**Review and Evaluation of  
Kentucky Mountain Power  
Site Assessment Report**

July 12, 2002

Kentucky State Board on Electrical Generation and Transmission Siting  
211 Sower Boulevard  
P.O. Box 615  
Frankfort, Kentucky 40602

BBC Research & Consulting  
3773 Cherry Creek N. Drive, Suite 850  
Denver, Colorado 80209-3827  
303.321.2547 fax 303.399.0448  
www.bbcresearch.com  
bbc@bbcresearch.com

**Exhibit C-1.  
General Location of  
Utility Routes Serving KMP**

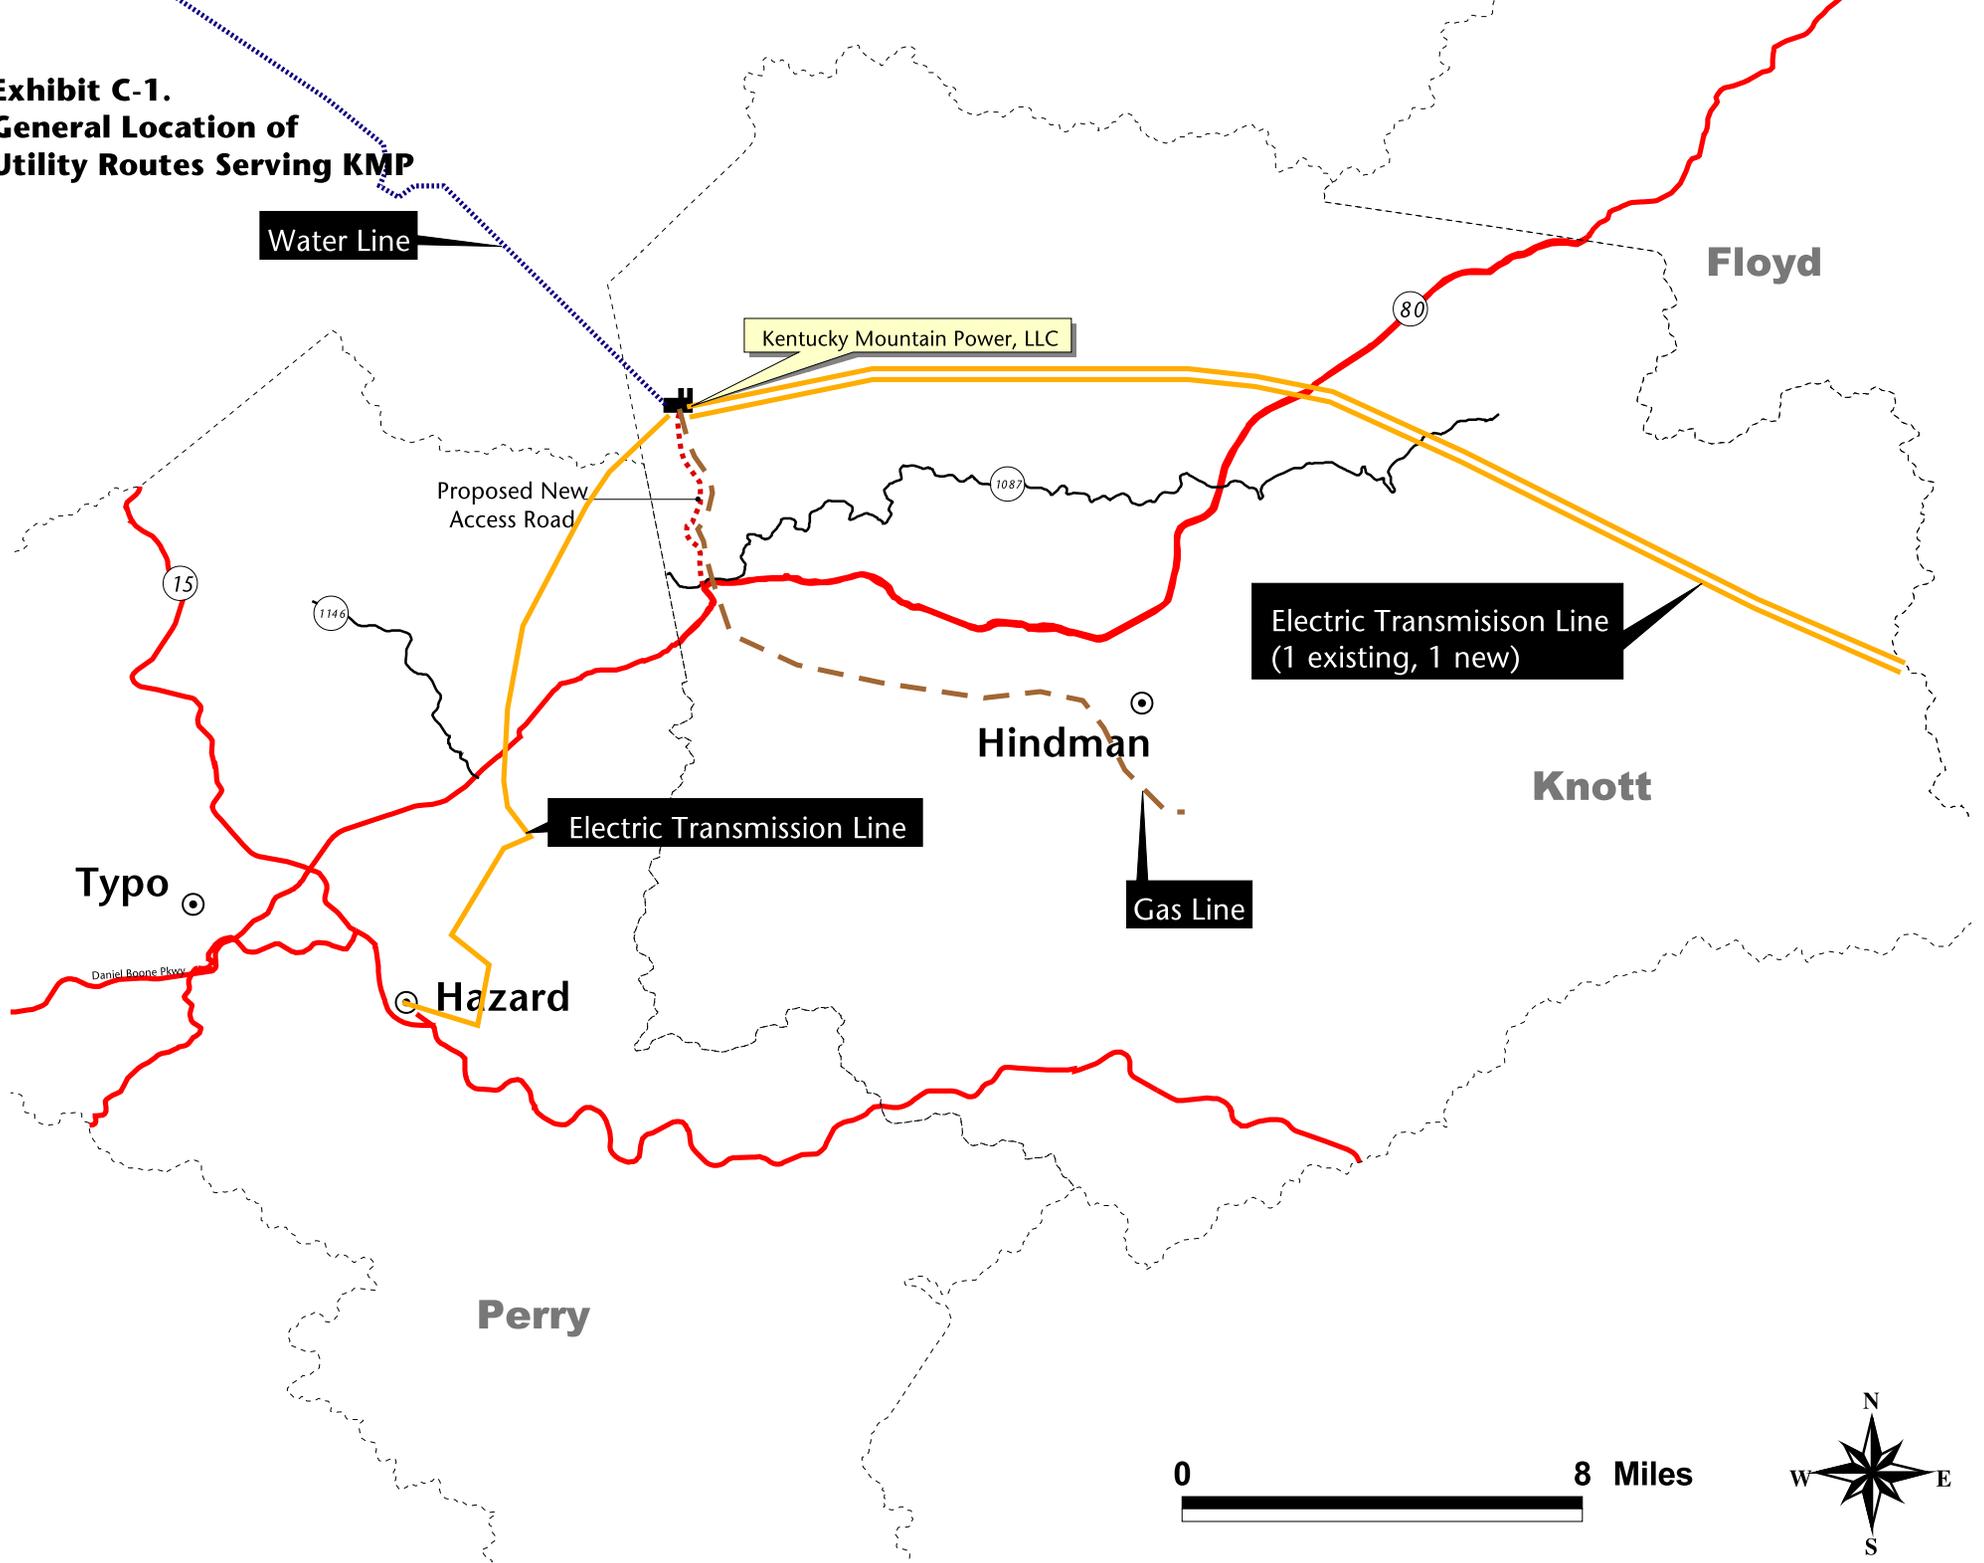
KMP did provide both a map (“Waterline Right-of-way Map”) of the proposed water conveyance system and a Term Sheet, dated August 1, 2001 and signed by both KMP and U.S. Filter Corp, that documented the details of the proposed water and wastewater service to the power plant. This term sheet described the facilities and services associated with constructing, operating and maintaining both potable and non-potable water service to the plant and associated facilities. The term sheet also describes similar commitments to provide wastewater treatment for domestic uses at the power plant and industrial park.

Apart from water and wastewater features within the leasehold, the proposed water system will also require a pumping station on the North Fork of the Kentucky River and approximately 19 miles of buried pipeline to reach Starfire Mine, plus four more miles of pipeline from the edge of the mine property to the power plant site. While the BBC team was unable to visit the full conveyance route, we did visit the location of the proposed pumping station. This facility would be located north of Kragon, along KY 15. The location is along a relatively deserted stretch of river, and it appears there is probably only one existing structure within 500 feet of the proposed pumping station. This structure, an occupied home, would be separated from the proposed pumping station by the KY 15 roadway and, at present, dense vegetation. The study team estimates this home is approximately 200 to 400 feet from the location of the proposed pumping station.

- Agreements for most utility services appear to be in place, with the exception of a formal agreement on natural gas service to the plant site. Presumably, Equitable Energy will comply with all state and federal requirements for constructing and operating the gas line to the site, including any required mitigation. The extensive water conveyance system envisioned for this facility includes a riverside pumping station and 19 miles of 30-inch buried pipeline. Impacts of these related facilities, if any, should also be subject to this SAR.

1. KMP should modify their definition of the "site" to include additional portions of their leasehold in order to meet the setback requirements in the legislation and to fully contain the access control fence surrounding the plant.
2. The applicant should modify their access control and security plans to follow industry standards, as described earlier.
3. The water pumping plant should be designed and constructed to minimize its visibility and noise from KY 15 and the existing residence located in the area. Enclosing the pumps within a fully enclosed building, including internal noise baffling, and minimizing visibility by developing an appropriate exterior to the pumping plant and maintaining vegetative screening to the extent possible should minimize any impacts associated with this facility.

**Exhibit C-2.  
Kentucky Mountain Power  
Primary Traffic Routes and  
Baseline Traffic Counts**

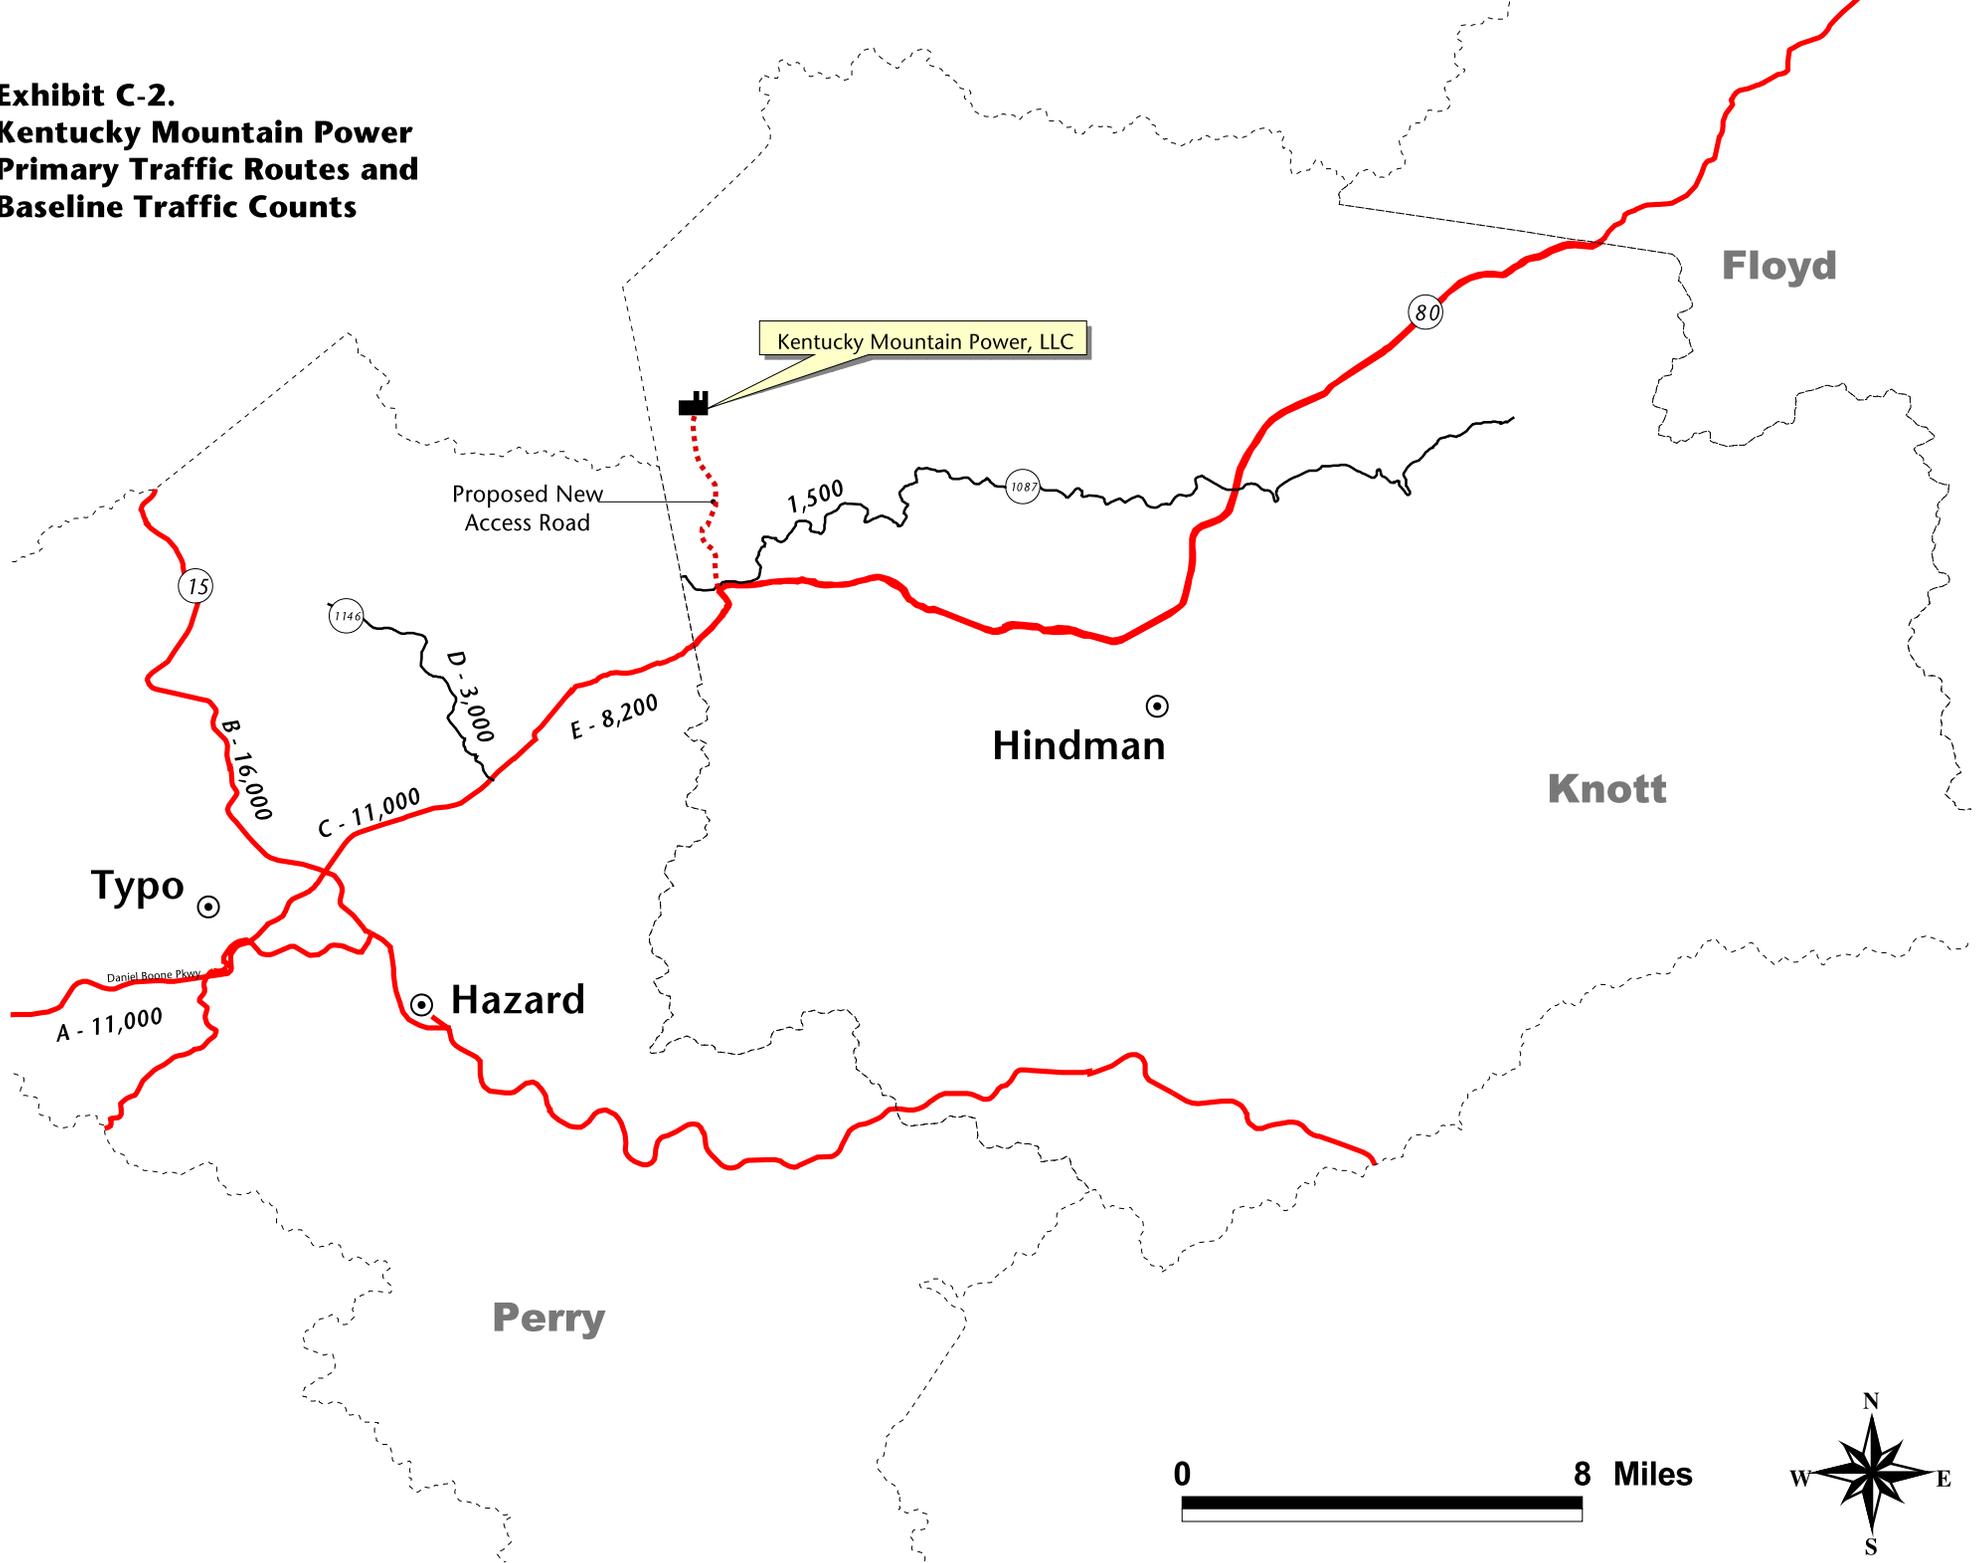
Exhibit C-2, on the following page, depicts the primary transportation routes for fuel and limestone in the vicinity of the proposed plant site. For purposes of assessing the range of potential transportation impacts later in this section of the report, the BBC team has developed two scenarios. The first scenario assumes that most of the fuel required by the plant will be procured from the Starfire Mine, with the exception of waste fuel sources already under contract. The second scenario assumes the worst case, from the standpoint of potential transportation impacts, that no fuel is obtained from the Starfire Mine. These subsequent impact assessments examine baseline traffic conditions and projected increases in traffic along key segments of the road system proximate to the proposed site and labeled A through E on Exhibit C-2.

Exhibit C-2 depicts the most recent daily traffic counts on the primary access routes to and from the plant site. Traffic along KY 80 ranges from about 8,200 vehicles per day in the segment containing the future access route to the plant site upward to nearly 11,000 vehicles per day in the segments east and west of the interchange with KY 15. Traffic along the segment of KY 15 immediately north of the interchange with KY 80 averages as much as 16,000 vehicles per day.<sup>46</sup>
